PLANNING DIRECTOR'S VARIANCE
1231 "I" STREET, SUITE 200, SACRAMENTO, CA 95814

- APPLICATION:**
- A. Negative Declaration
 - B. Planning Director's Variance to reduce the required side yard setback from five feet to three feet on 0.11 ± vacant acres in the Standard Single Family (R-1) zone.
 - C. Planning Director's Variance to allow a masonry wall to exceed the six foot height requirement by two feet.

LOCATION: 1832 51st Street

APPLC. NO. P90-472

NORTH ELEVATION
SCALE 1/4" = 1'-0"

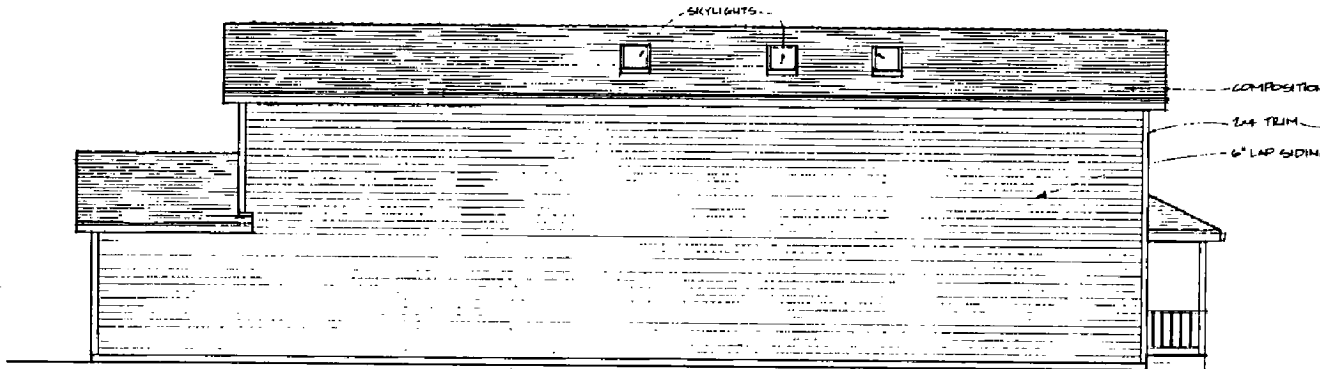
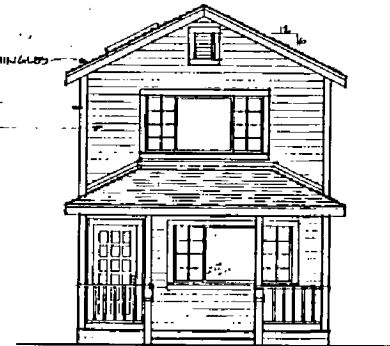
The proposed elevations show horizontal lap siding with a composition shingle roof. Staff recommends a 2x12 wood band painted in the trim color be added to the north and south elevation to align with the first story roof. Staff also recommends the roof be constructed with 25 year laminated dimensional composition shingles and the garage door be a metal sectional door.

- 1. The applicant shall add a 2x12 wood band painted in the trim color to the north and south elevation to align with the first story roof. The roof shall be constructed with 25 year laminated dimensional composition shingles and the garage door shall be a metal sectional door. The elevations shall be revised and submitted to Planning Staff for review and approval prior to the issuance of building permits.
- 2. The size, style, and location of the house on the site shall conform to the plans submitted.
- 3. The applicant shall obtain all necessary building permits prior to commencing construction.
- 4. The applicant shall comply with the mitigation measures of the Negative Declaration.
- 5. The applicant shall comply with all applicable ordinances pertaining to hours of operation for on-going construction. All equipment and debris shall remain on the subject parcel.
